The Commission has issued the enclosed Amendments Nos. 105 , 105 , and 102 to Licenses Nos. DPR-38, DPR-47 and DPR-55 for the Oconee Nuclear Station, Units Nos. 1, 2 and 3. These amendments consist of changes to the Station's common Technical Specifications (TSs) in response to your applications dated May 29 and August 25, 1981, as supplemented by letter dated October 16, 1981.

These amendments revise the TSs to allow full power operation of Unit 1 for fuel cycle 7, reflect completed modifications to the high pressure injection system and revisions to the boron concentration requirements.

AMENDMENT TO FACILITY OPERATING LICENSE

ATTACHMENT TO LICENSE AMENDMENTS

CORE PROTECTION
SAFETY LIMITS
UNIT 1
OCONEE NUCLEAR STATION
Figure 2.1-2A

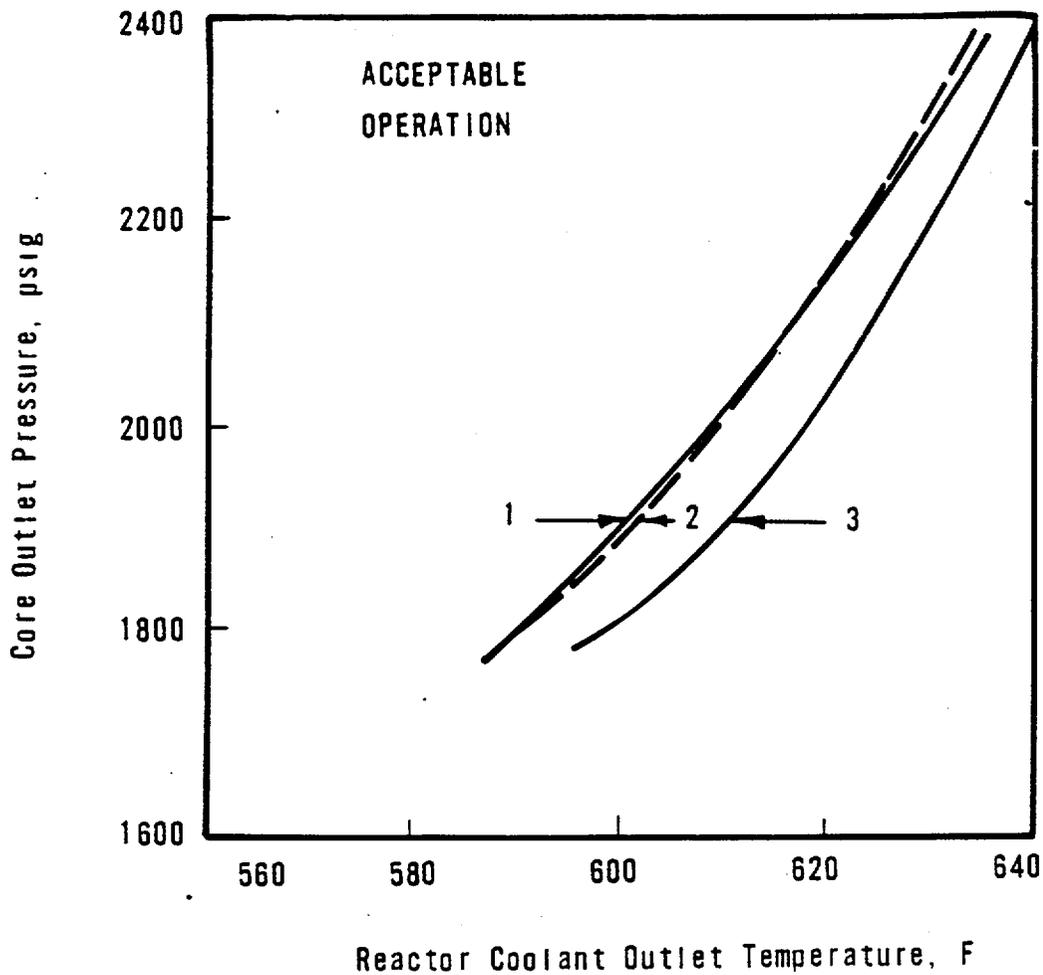
The curves of Figure 2.1-2A are based on the more restrictive of two thermal limits and include the effects of potential fuel densification and rod bowing:

The specified flow rates for Curves 1, 2, and 3 of Figure 2.1-2A correspond to the expected minimum flow rates with four pumps, three pumps, and one pump in each loop, respectively.

PROTECTIVE SYSTEM MAXIMUM ALLOWABLE SETPOINTS
 UNIT 1
 OCONEE NUCLEAR STATION
 Figure 2.3-2A

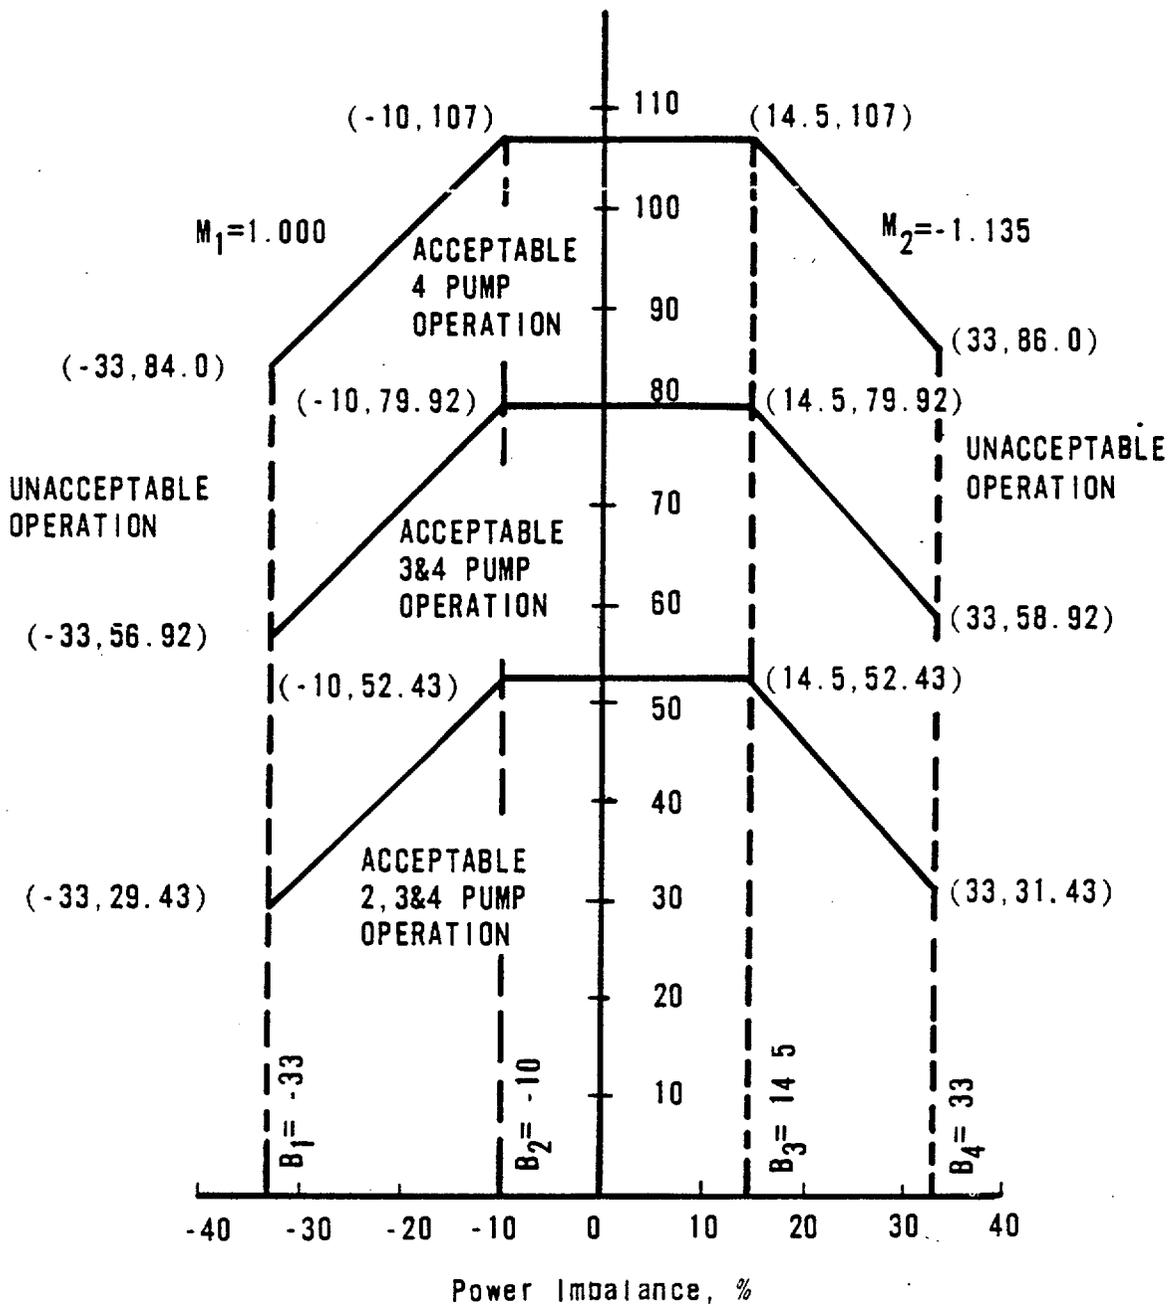
The power-imbalance boundaries are established in order to prevent reactor thermal limits from being exceeded. These thermal limits are either power peaking kw/ft limits or DNBR limits. The reactor power imbalance (power in the top half of core minus power in the bottom half of core) reduces the power level trip produced by the power-to-flow ratio such that the boundaries of Figure 2.3-2A - Unit 1 are produced. The power-to-flow ratio reduces the power

level trip and associated reactor power/reactor power-imbalance boundaries by 1.07% - Unit 1 for 1% flow reduction.
